**5.0 Design Development**

### 5.1 - Discussion with Camden Council Design Officer 22.09 2010

Fig - 5.5.1 - Sketch by Camden Council's Design Officer Showing Deep Cut Outs and Protruding Boxes

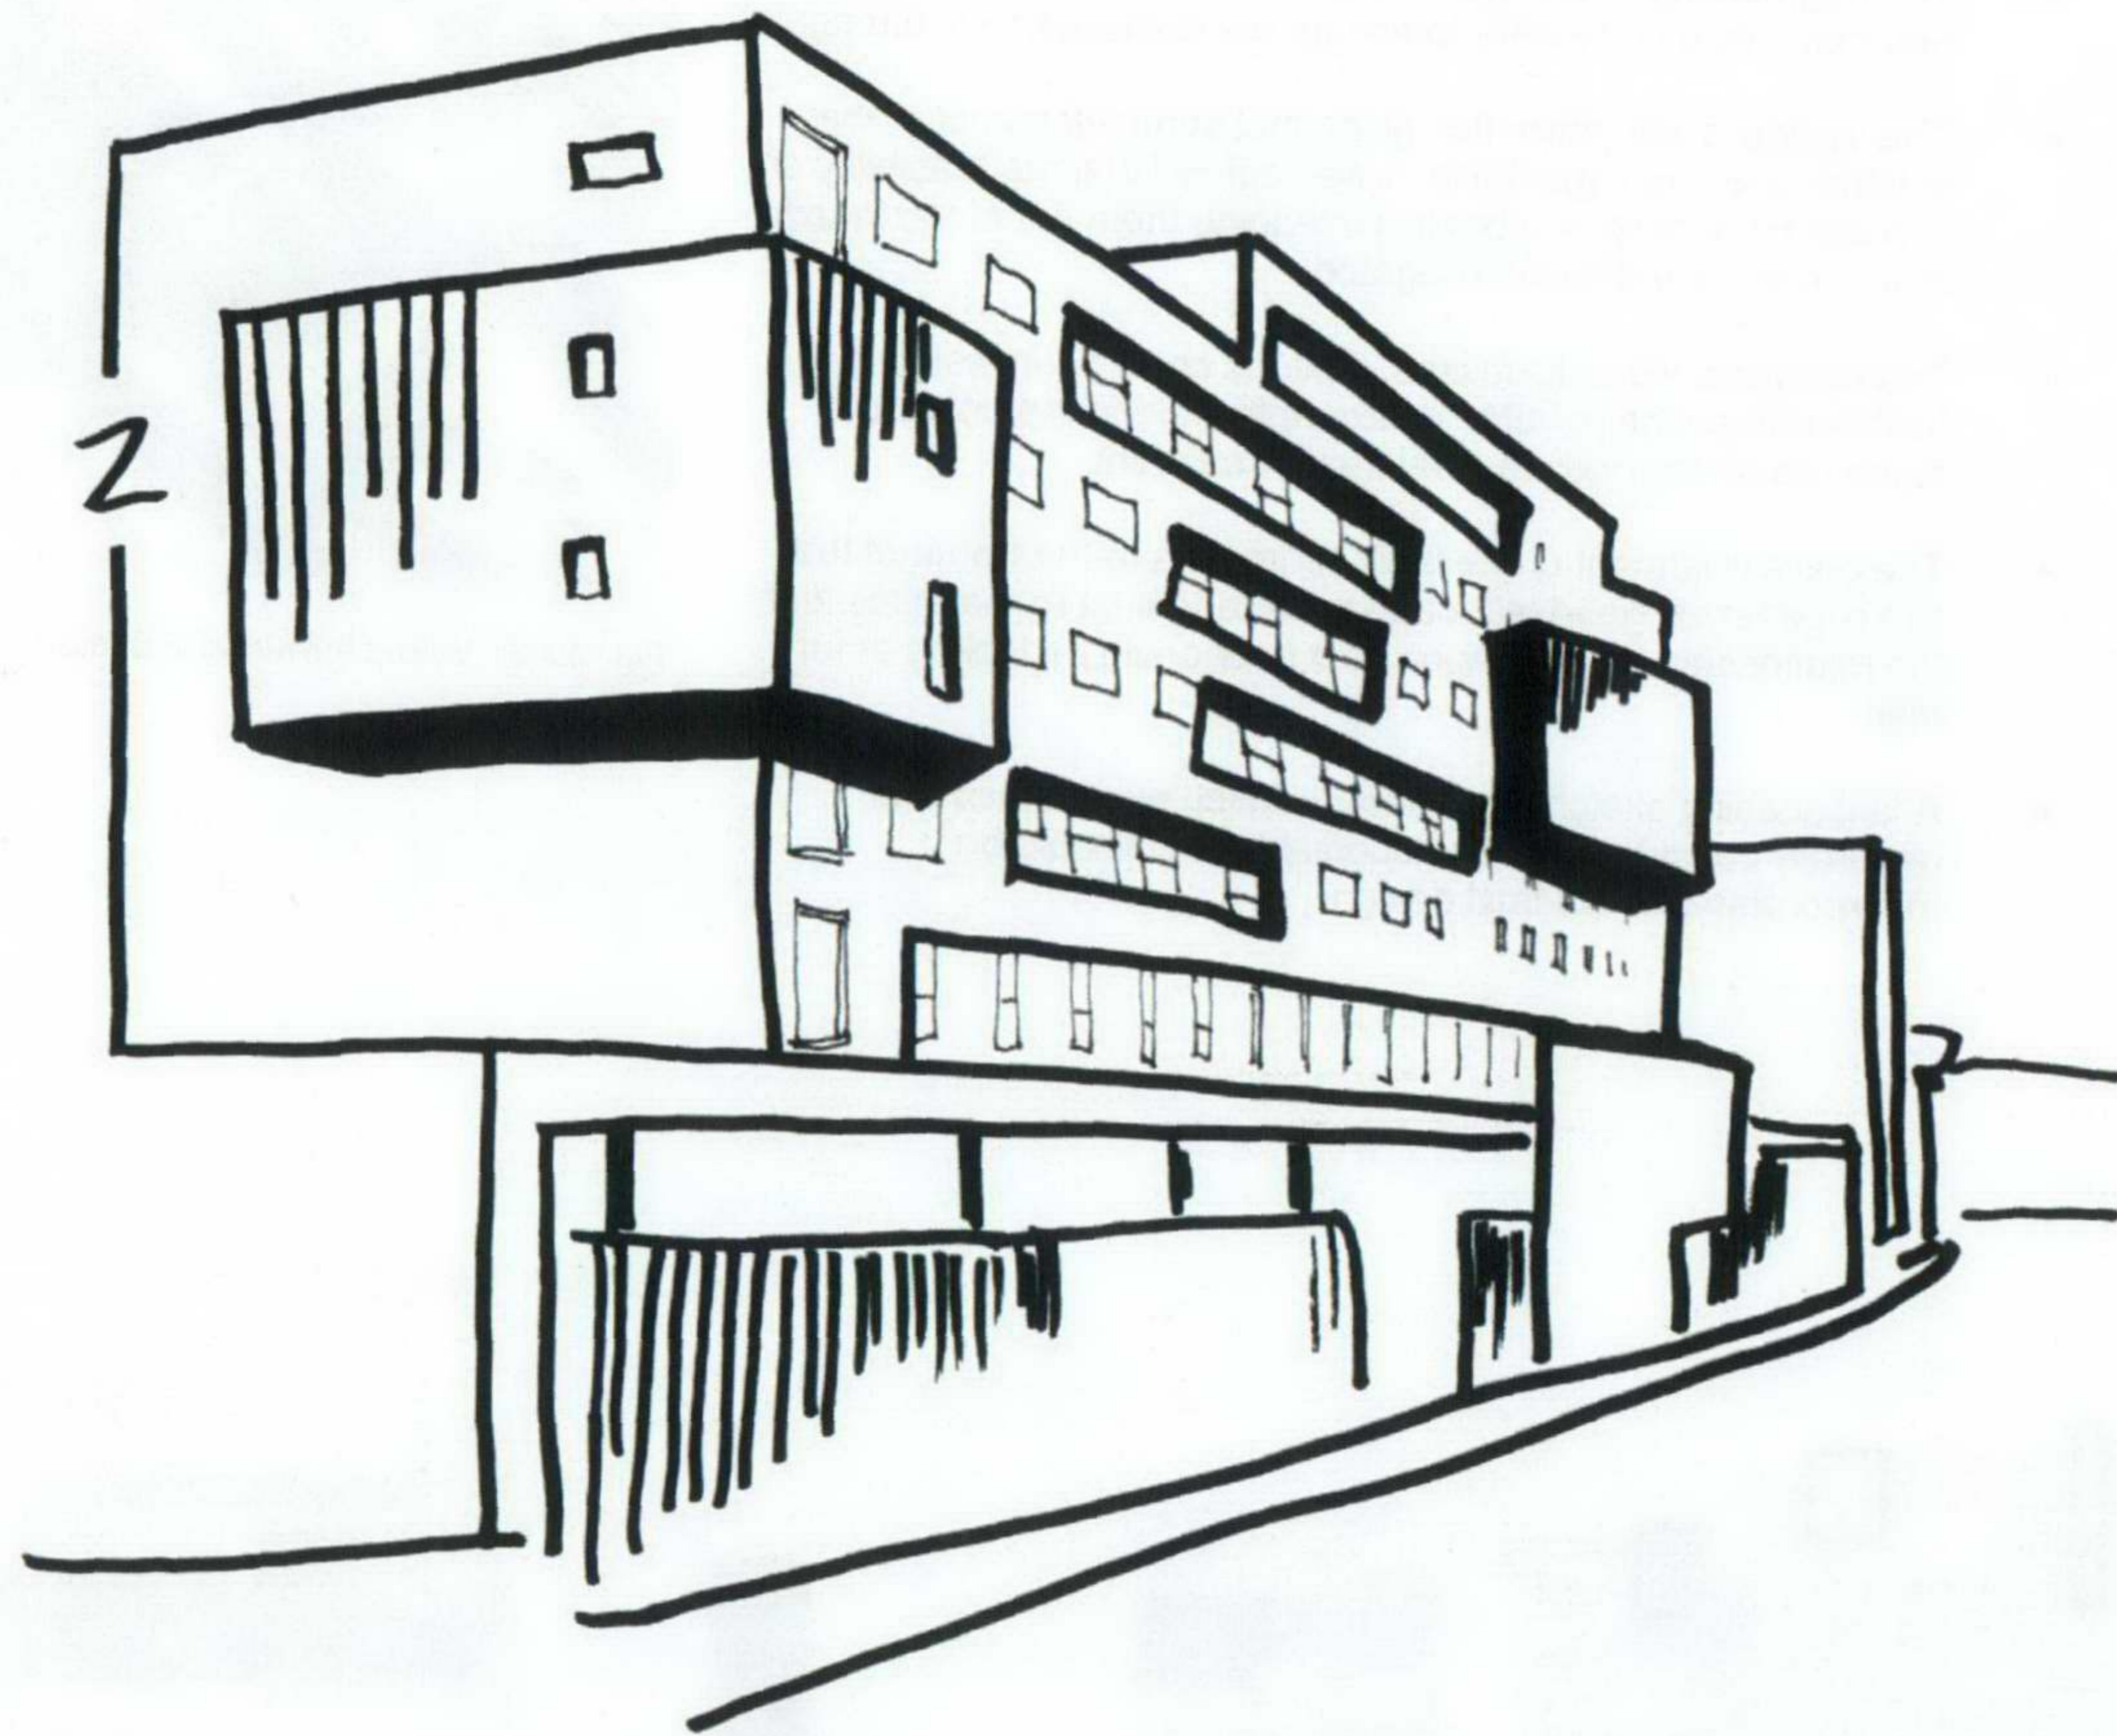
- The façade is still rather flat, given that some elements of the scheme are very expressive. It was agreed that the feasibility of expressing a few of the boxes by leaning them out of the façade much more, would be investigated.
